Component Development Div.
Canon ANELVA Corporation

P-878CA Compressor Unit Product Discontinuation Notice

CSW-61CN2 / P-878CA Compressor Unit Comparison

1. Unit Appearance

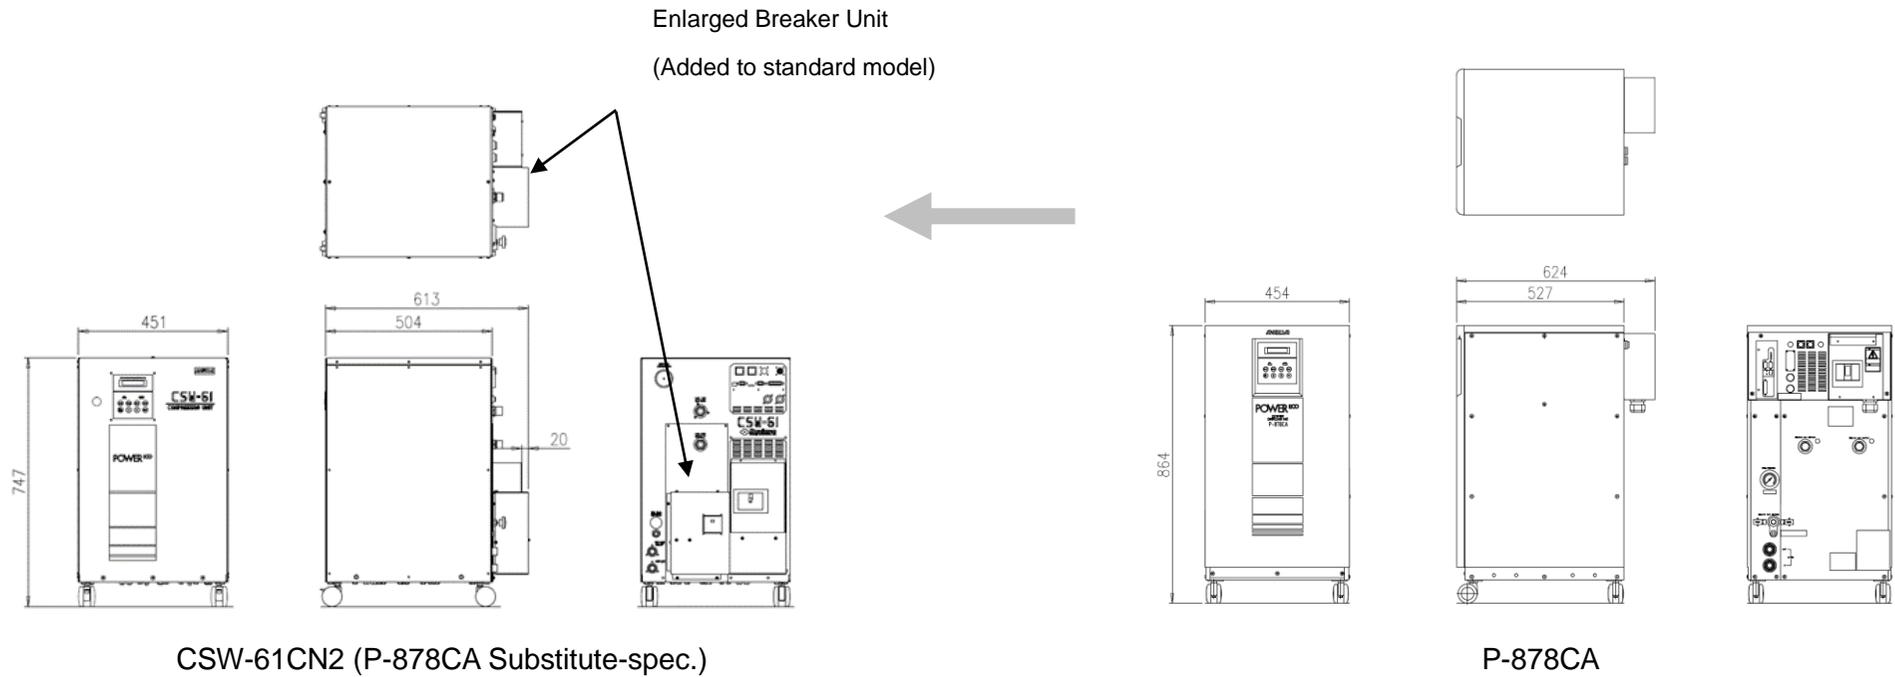
- ※ Upgrading an existing P-878CA will require the 30A circuit breaker box to be added on the back of CSW-61CN2.
The interface locations of the helium gas fitting, the coolant plumbing, and the cable connection will be different from the original P-878CA.
The existing anchor bolts and its locations can be utilized for fixing CSW-61CN2 with the dedicated seismic bracing plates.
